Subject: River Bend Station  
Docket No. 50-458  
License No. NPF-47  
Revised Response to NRC Request for Additional Information Regarding  
Proposed Amendment to Revise Reactor Vessel Pressure/Temperature Limits  
(TAC NOS. MB1114 and MB1153), LAR 2000-26

Response to Request for Additional Information

**SUBJECT: NRC Request for Additional Information (RAI) for River Bend Reactor Vessel**  
**Pressure/Temperature Limits**

Figure 5-10. P-T Curves A, B, and C up to 32 EFPY

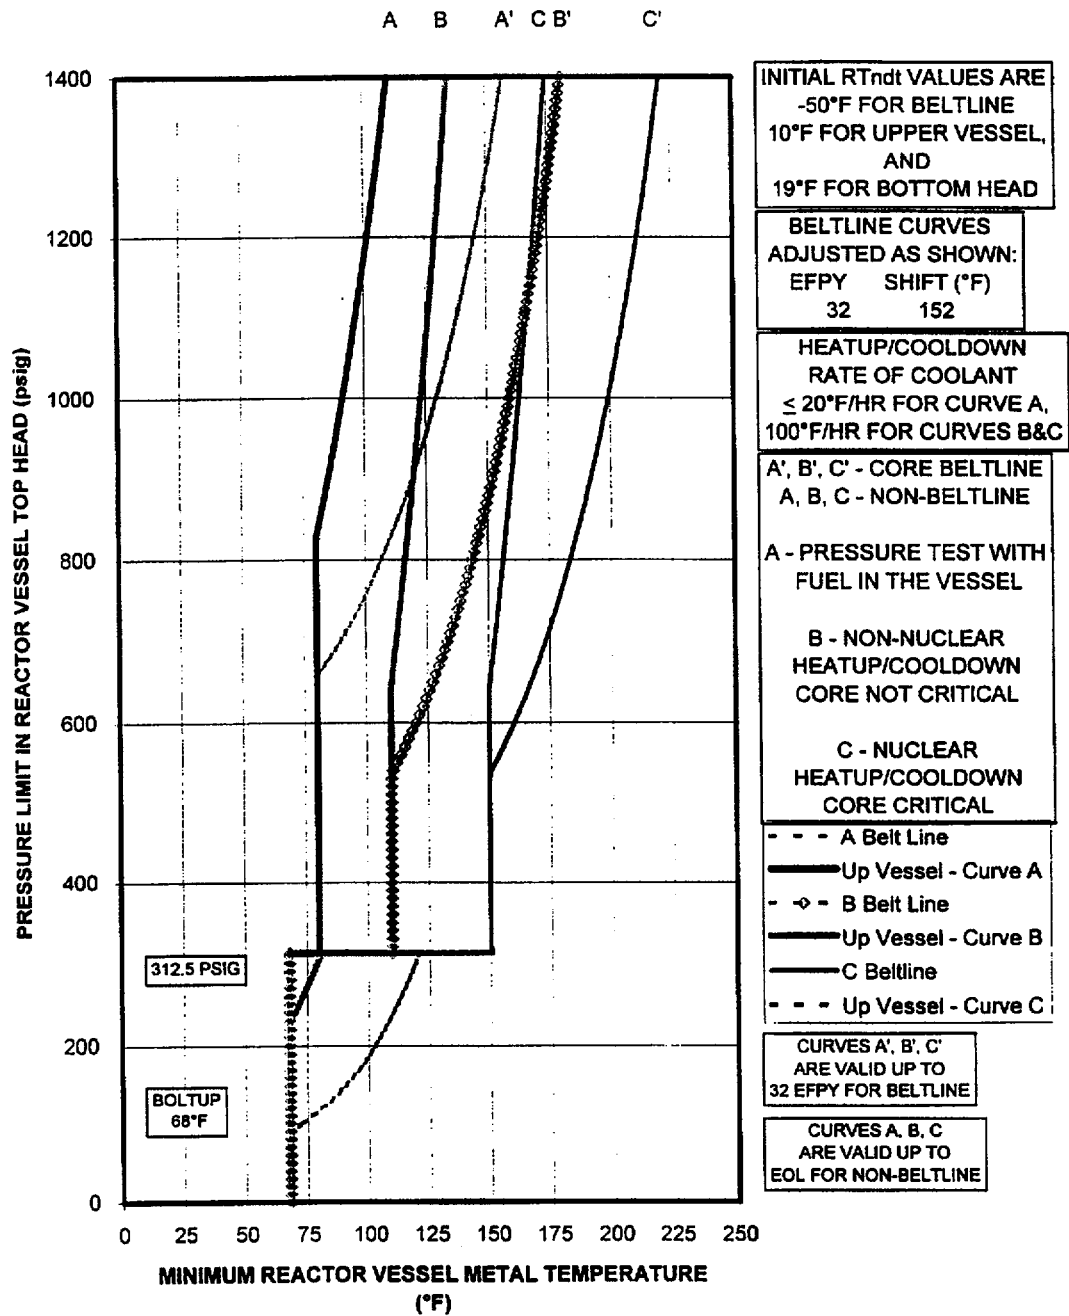
Page 57: The P/T limit curve for the core beltline B' was missing in Figure 5-10. Please provide a complete Figure 5-10.

- 4. Page 57: The P/T limit curve for the core beltline B' was missing in Figure 5-10. Please provide a complete Figure 5-10.**

The P/T limit curve for the core beltline B' was included in the Final report as issued (The correct values are listed in Table 5-10). The line is difficult to see due to the coloring/shading of the line. A revised Figure 5-10 (page 57) is attached with the P/T limit curve for the core beltline B' clearly marked.

*The P/T limit curve for the core beltline B' was included in the Final report as issued (The correct values are listed in Table 5-10). The line is difficult to see due to the coloring/shading of the line. A revised Figure 5-10 (page 57) is attached with the P/T limit curve for the core beltline B' clearly marked.*
